TRUCK UTILITY MEDIUM (HS) HT W/ VPK2 24 V (WITH ACU) REFURBISHED
2005 [REDACTED]

MODIFICATION INSTRUCTION NO 17

SUBJECT: Rear door release mechanism

SUBJECT: Replacement of the speedometer drive gear – (SNATCH-VIXEN PLUS)

Fig 2 Electric cable and hose assembly (Removal)

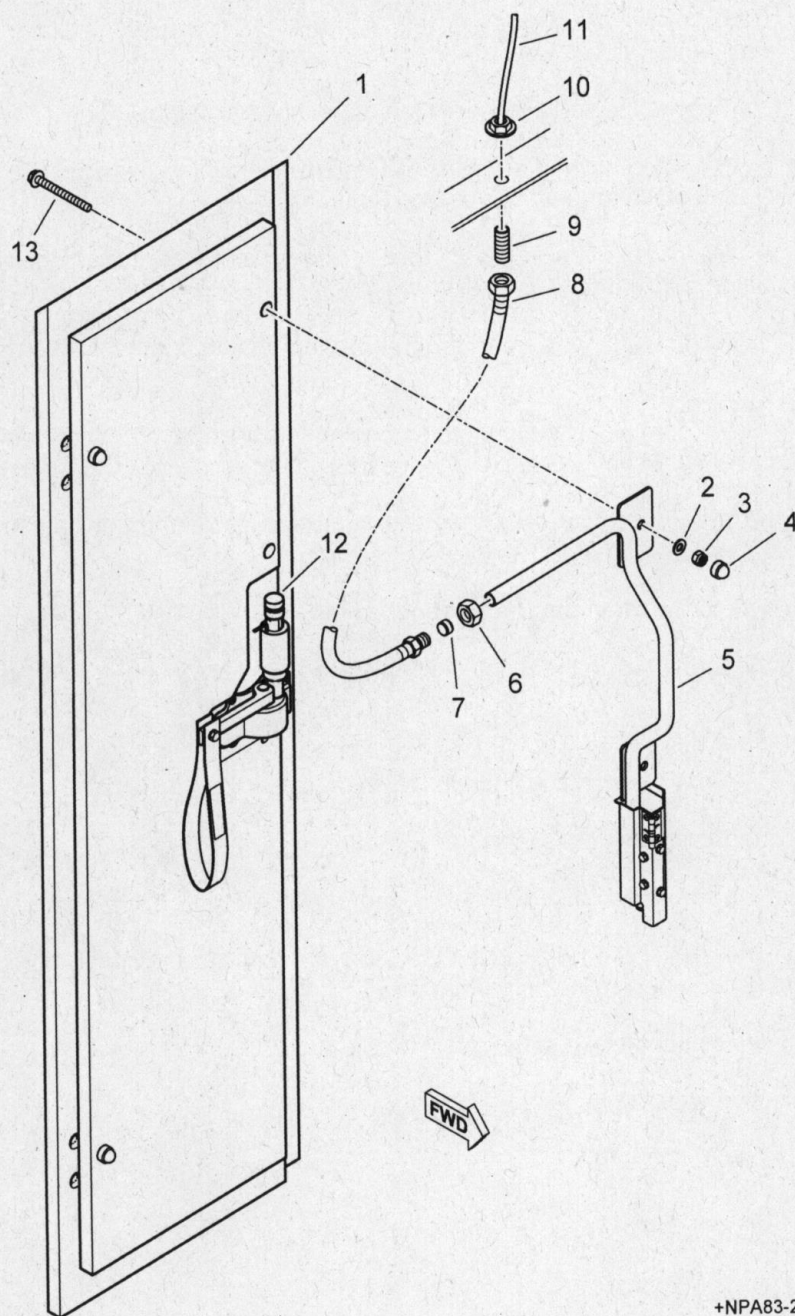
1 To support the role of the TRUCK UTILITY MEDIUM (HS) HT W/ VPK2 24V (WITH ACU) REFURBISHED 2005 [REDACTED], it has been assessed that a revised rear door hose assembly is fitted.

14 To remove the electric cable (Fig 2(11)) and hose assembly (8), proceed as follows.

14.5 Holding the hose assembly, remove flanged nut (Item 2)(10) securing the connector (Item 12)(9) to the rear roll bar.

14.6 Remove union nut (Item 14)(6) from the hose.

14.8 Discard hose, flanged nut, connector, olive washer and union nut.

15 To fit the and hose assembly (Item 1), proceed as follows:

15.1.2 Remove union nut (Item 5)(Fig 2(6)) and olive washer (Item 6)(7) from hose assembly then place on previously removed trunking (5).

15.1.3 Push hose on trunking then secure using the olive washer and union nut. Tighten union nut securely. Do not over tighten.

15.1.4 Remove flanged nut (Item 2)(10) then ensure connector (Item 3)(9) is tight in the hose.

15.1.5 Fit connector through the opening in the rear roll bar then secure using the previously removed flanged nut. Do not over tighten.

Fig 1

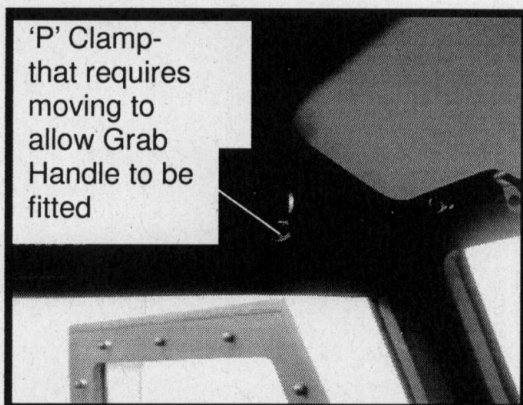
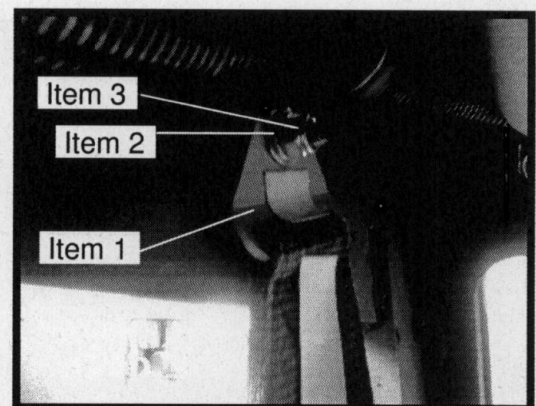
1. This instruction introduces a grab handle, to be used by the vehicle commander to aid ingress into the vehicle.

- 9.1. Undo and discard the nut (item 4) securing ECM conduit 'P' clamp forward of loud speaker illustrated in Fig 1.
- 9.2. Remove the 'P' clamp from bolt shaft.
- 9.3. Fit grab handle (item 1) as illustrated in Fig 2, replace 'P' clamp and fit new washer (item 2) and M8 Nyloc nut (item 3) to bolt and torque to 35 Nm (26 Lb/ft).
- 9.4. Check security of grab handle, and drivers vision is not impaired.

Fig 1 Replacement speedometer drive gear

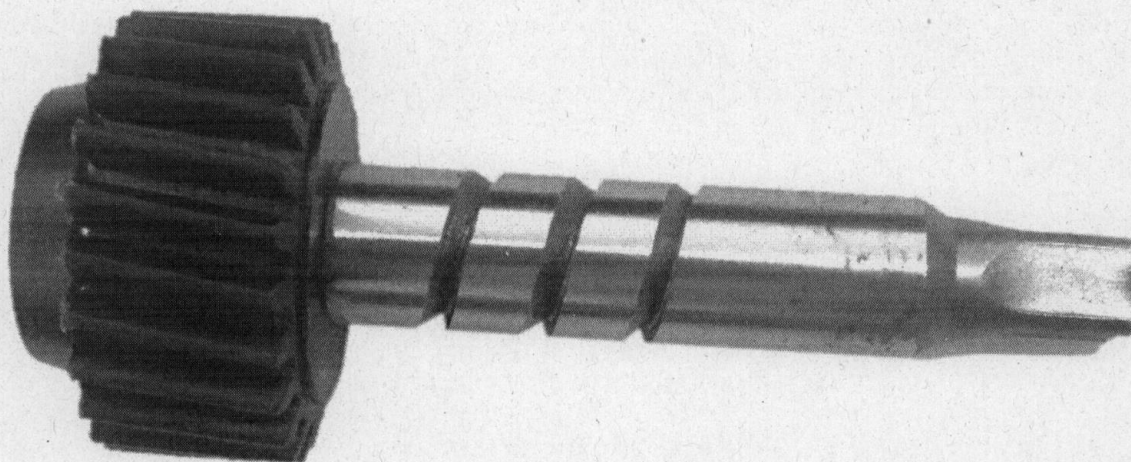
1 Following the introduction of the revised final drive axle ratios fitted to SNATCH-VIXEN PLUS during the UOR upgrade, a new speedometer drive gear has been introduced to correct the speedometer readout inaccuracy resulting from the axle ratio change.

8.1.1 The following items are to be demanded quoting this instruction as authority for demand. Fig 1 shows the item of the modification part.

The drive gear removed item may be Blue (20 teeth) or Green (21 teeth). Ensure that the replacement drive gear is Red and has 24 teeth.

Fig 5 Drive housing and gear

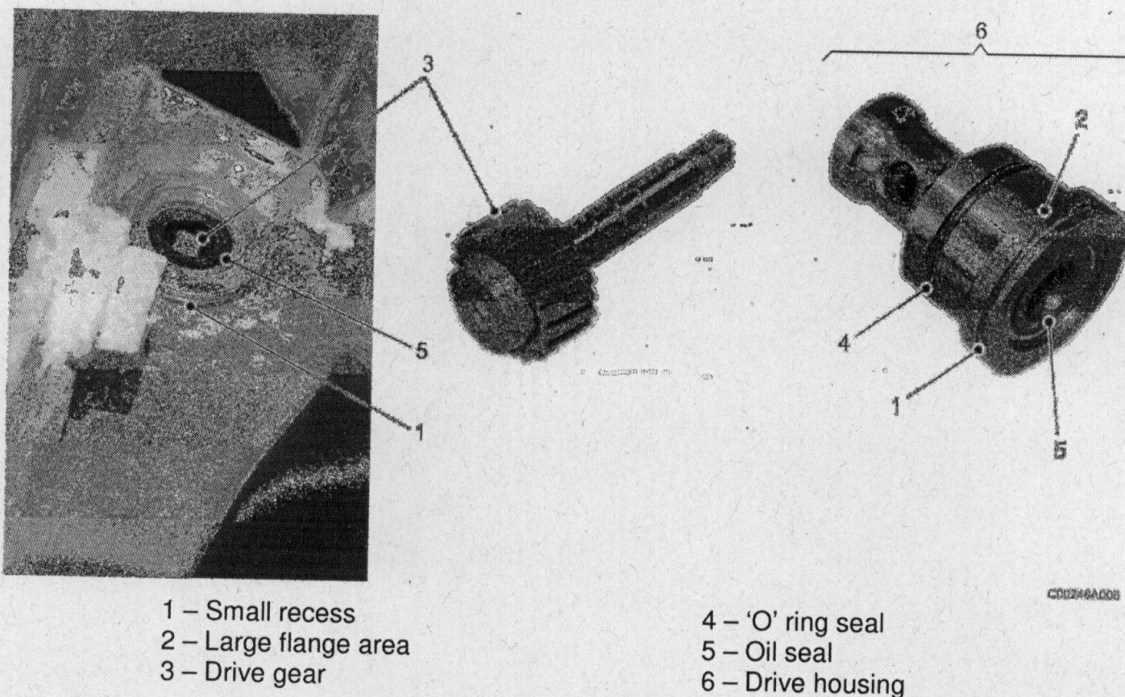
10.7 Refer to Fig 5. Locate the small recess (Fig 5.1) on the speedometer drive housing (Fig 5.6), insert a small flat blade screwdriver into the recess and lever out the drive housing. When the drive housing has been extracted by approximately 5mm a larger flange area (Fig 5.2) is revealed, and a larger screwdriver can now be inserted to allow greater leverage on the drive housing.

10.8 Once the drive housing is loose, pull it free from the transfer box housing, remove the drive gear (Fig 5.3) and discard.

- 11 To reassemble the speedometer drive, proceed as follows:
 - 11.1 Identify the replacement part and ensure that it is serviceable.
 - 11.2 Ensure the oil seal (Fig 5.5) is serviceable, replace if necessary.
 - 11.3 Apply a light smear of grease to the drive gear shaft and the outside of the drive housing, ensuring that the rubber 'O' ring seal (Fig 5.4) is still intact and serviceable, replace if necessary.
 - 11.4 Insert the drive gear (Fig 5.3) into the drive housing.
 - 11.5 Insert the drive gear and drive housing carefully back into the transfer box housing, ensuring that the drive gear has fully engaged with the internal drive gear and that the drive housing is fully seated.
 - 11.6 Replace the electronic sensor and secure in place with the 10mm screw and spring washer.
 - 11.7 Refit the speedometer cable connection, ensuring that it clips and locks into place.
